ENCLOSURE License No. DPR-31, DPR-41 & DPR-67
Appl for Amend: tech specs proposed change
concerning revision of Figure 6.2-1 to reflect
recent minor changes to the offsite organization...
Notorized 09/06/77...w/att Cert of Svc...

PLANT NAME: TURKEY UNITS 3 & 4

Re: Turkey Point Units 3 and 4 and
St. Lucie Unit 1, Docket Nos. 50-250,
250-251 and 50-335 - Proposed Amendment
to Facility Operating Licenses DPR-31,
DPR-41 and DPR-67

FIGURE 6.2-1 OFFSITE ORGANIZATION CHART

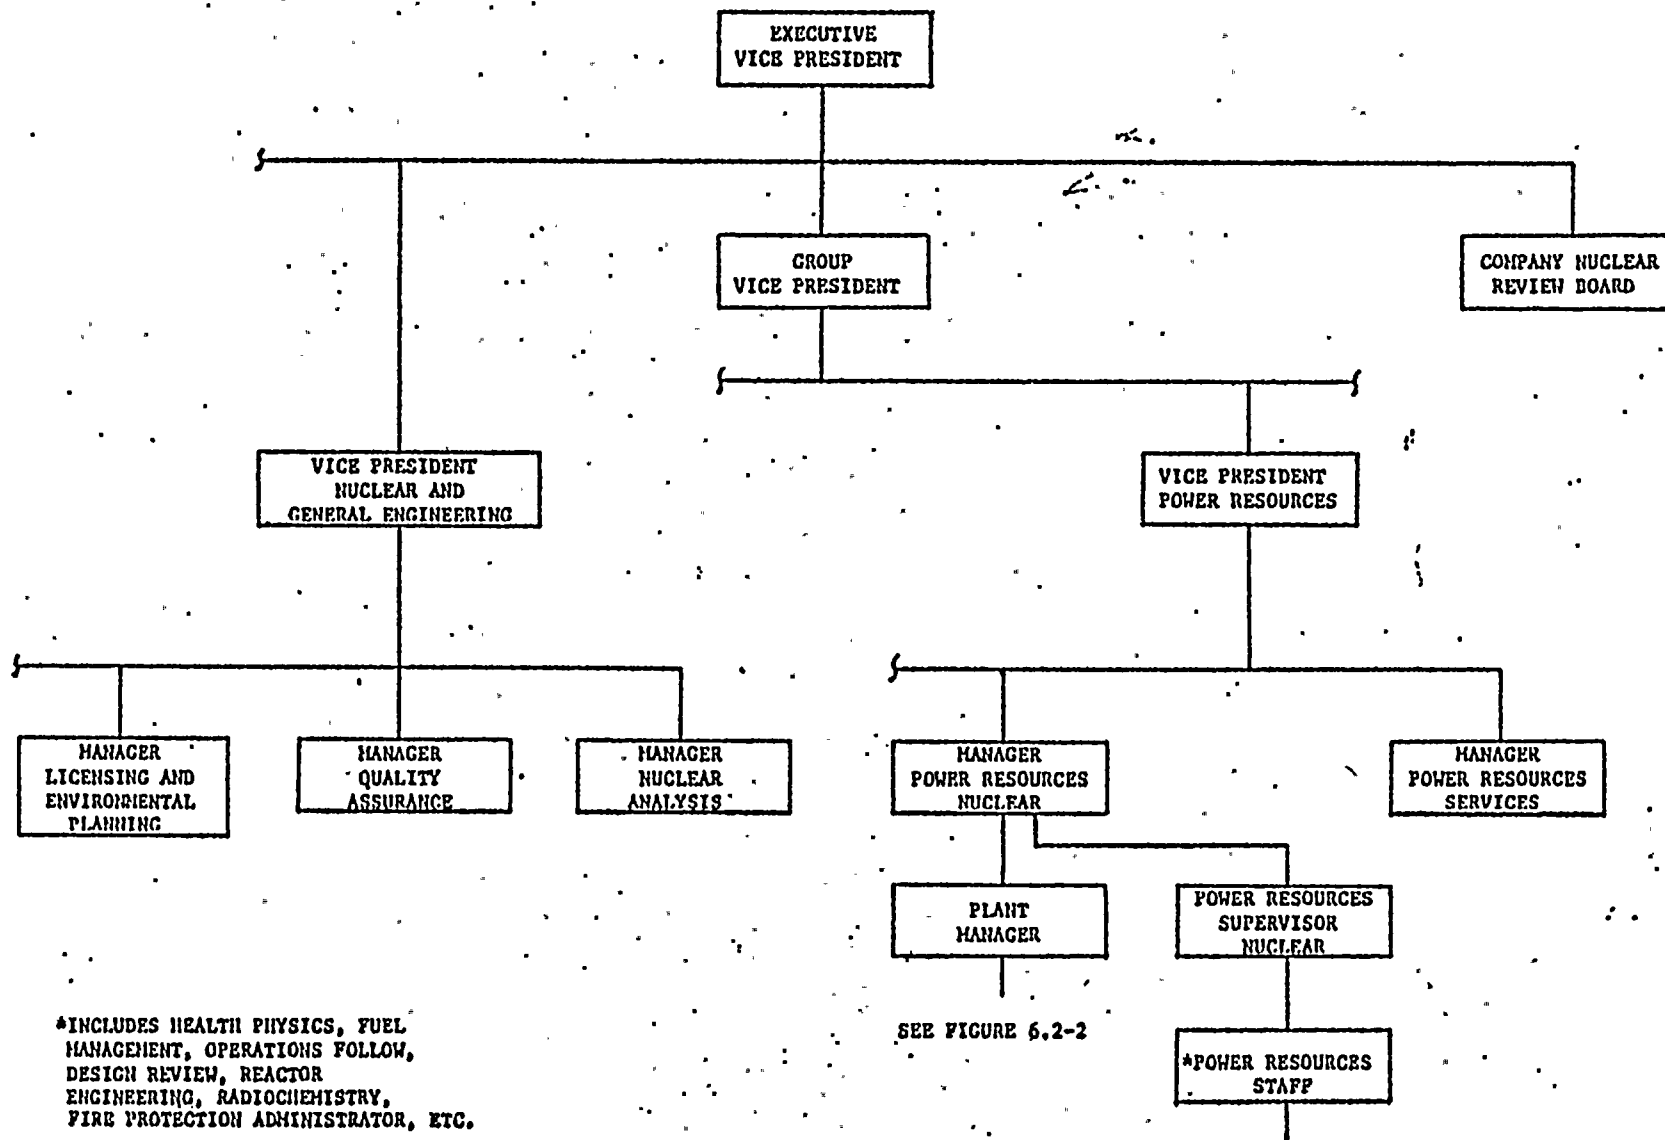
Figure 6.2-1 is revised to reflect recent minor changes in our offsite organization. Two positions have new titles (Vice President-Nuclear and General Engineering and Manager-Licensing and Environmental Planning). One position has been deleted (Vice President-Environmental Planning & Research).

Figure 6.2-1 on page 6-2 should be changed to reflect minor changes in the Florida Power & Light Company (FPL) offsite organization for management and support of nuclear facilities. Two positions have new titles and one position has been deleted as described in the cover letter.

The proposed amendment is administrative and does not involve the modification of any equipment or procedures. It does not involve a significant change in the management or support of FPL nuclear facilities; the responsibilities for research and environmental planning have been transferred to different people, but these responsibilities remain basically the same.
